## Introduction

This document describes the changes between the AMCC PowerPC 440GP and 440GX from a software perspective. The 440GX User's Manual and related documents will discuss the changes in detail. The purpose of this document is to highlight the changes and identify the areas where software updates may be necessary. The reader should be familiar with the details of the 440GP before reading this document.

**Figure 1: Interrupts in 440GP-compatible mode**

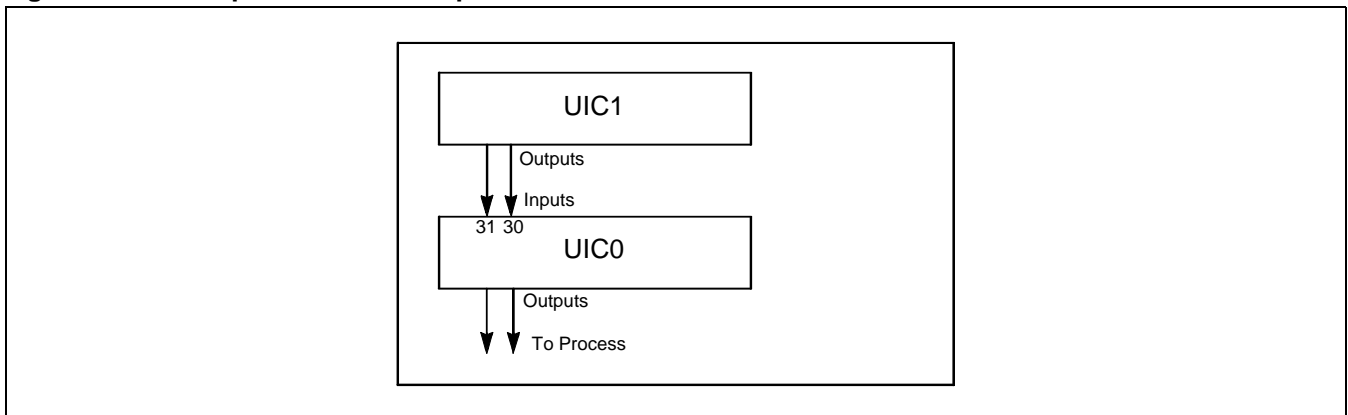
On the 440GP there are two universal interrupt controllers (UICs), known as UIC0 and UIC1. Each has 32 inputs which come from either internal chip components or external devices. Each UIC has 2 outputs: one critical (high priority) and one non-critical. The outputs from UIC1 are cascaded into two of the inputs of UIC0 (30 and 31), then UIC0's outputs are connected to the processor, see Figure 1.

**Figure 2: Interrupts in 440GXmode**

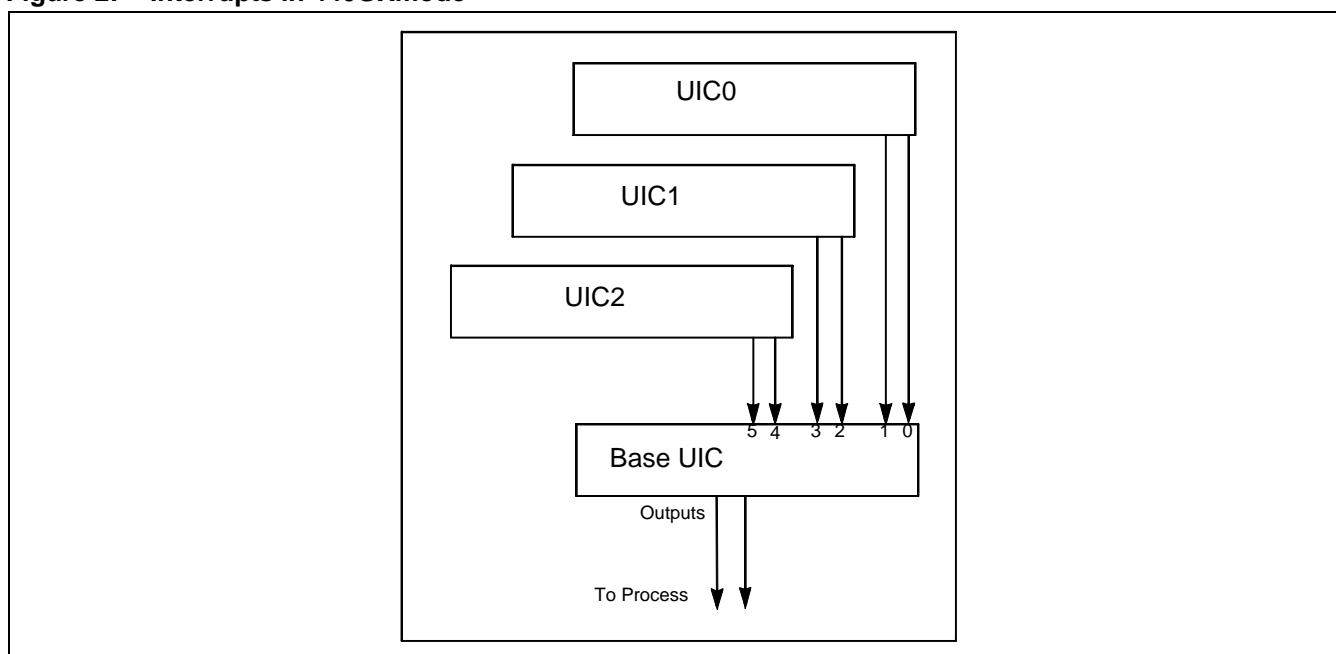
On the 440GX there are additional cores present, which have their own interrupts. In order to provide backwards compatibility with 440GP, a switch is provided which will allow the original two interrupt controllers to operate in 440GP-compatible mode. In this mode, all of the interrupts which were present in the 440GP are present in the same locations and no modification to software is needed. However, none of the interrupts from the new 440GX components are accessible in this mode (see "General Purpose Timers Changes" on page 12 for an exception to this).

The switch is implemented as a bit in the new SDR0\_MFR (Miscellaneous Function Register). In order to take advantage of the new components present in the 440GX, the switch must be set to “440GX-mode”. In this mode, a new UIC (UIC2) is present. The inputs to UIC2 are from the new interrupts available in the 440GX. The way that the UICs are connected is also changed, see Figure 2. Instead of UIC1 cascading its outputs into UIC0, the three UICs become peers, and each of them feeds its outputs into a “base UIC”. Thus the critical and non-critical interrupts from UIC0 are fed as inputs to the base UIC pins0 and 1. Similarly, the outputs from UIC1 go to input pins2 and 3 of the base UIC, and those from UIC2 go to pins4 and 5. All other input pins on the base UIC are reserved. The outputs of the base UIC drive the processor.

The interrupt handling code for this new 440GX configuration must take into account the new structure. Note that in this mode, UIC0 inputs30 and 31 are not used, and so must be masked off (these used to be the cascade inputs from UIC1 in 440GP compatible mode). Whenever an interrupt is received, the interrupt dispatch code should first check the base UIC to determine which of UIC0, UIC1 or UIC2 caused the interrupt, then check that UIC to determine the exact interrupt signal to be serviced. When clearing an interrupt, an interrupt handler should first clear the interrupt in the UIC to which it is attached (UIC0, UIC1 or UIC2), and then clear the corresponding cascade bit in the base UIC.

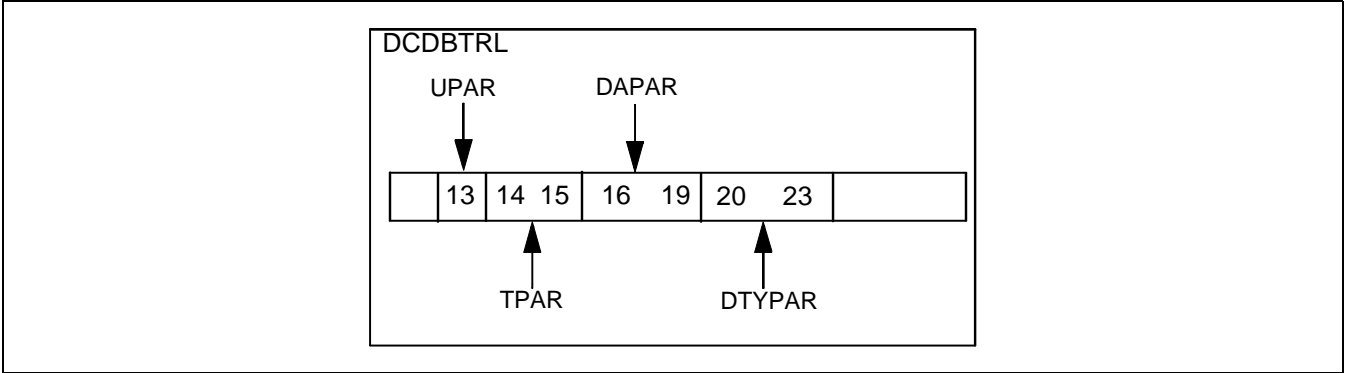
PRE Parity Recoverability Enable (for D-cache)  
CRPE Cache Read Parity Enable

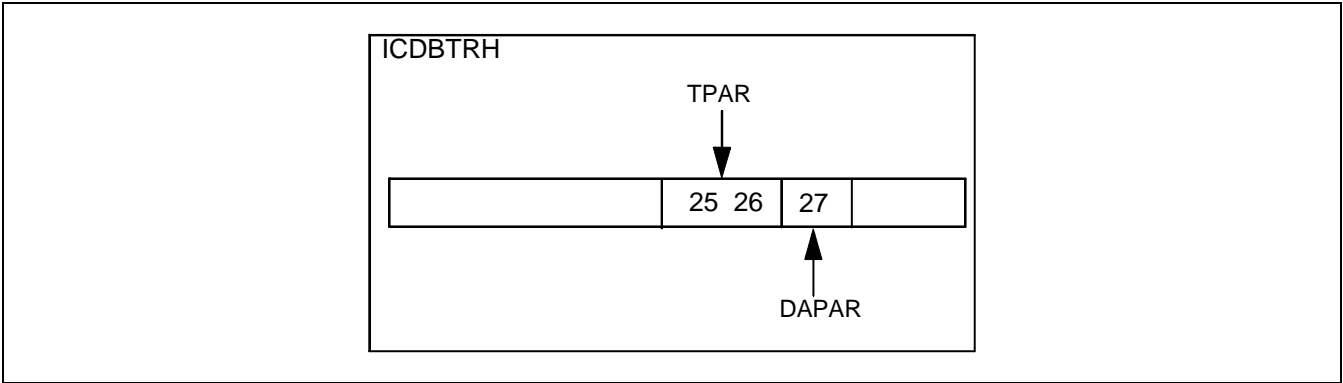
UPAR U-field parity  
TPAR Tag parity  
DAPAR Data Parity  
DTYPAR Dirty bits parity

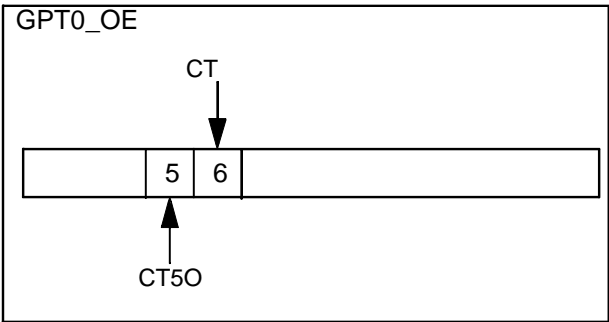
CT5M Compare Timer 5 Interrupt Mask  
CT6M Compare Timer 6 Interrupt Mask

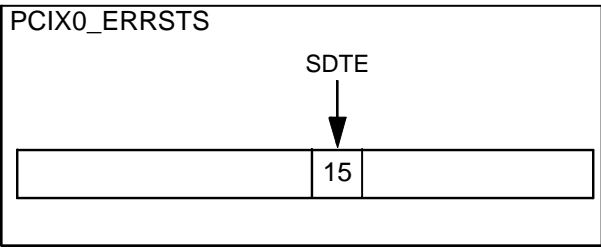
USEE Unexpected Split Completion  
Error Enable  
SDTE Outbound Split Discard Timer  
Enable

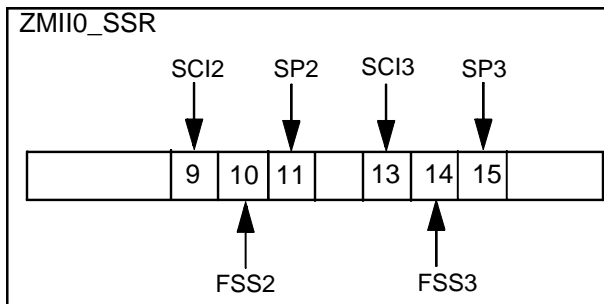
MDI2 EMAC2 MDI Enable  
SMII2 EMAC2 SMII Enable  
MDI3 EMAC3 MDI Enable  
SMII3 EMAC3 SMII Enable

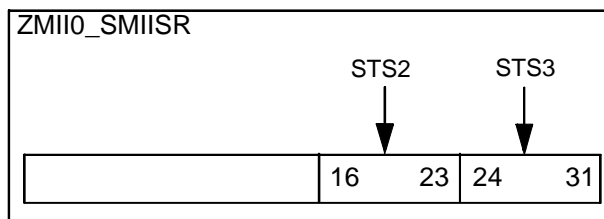
SCI2 EMAC2 Suppress Collision Indication  
 FSS2 EMAC2 Force Speed Selection  
 SP2 EMAC2 Speed Selection  
 SCI3 EMAC3 Suppress Collision Indication  
 FSS3 EMAC3 Force Speed Selection  
 SP3 EMAC3 Speed Selection
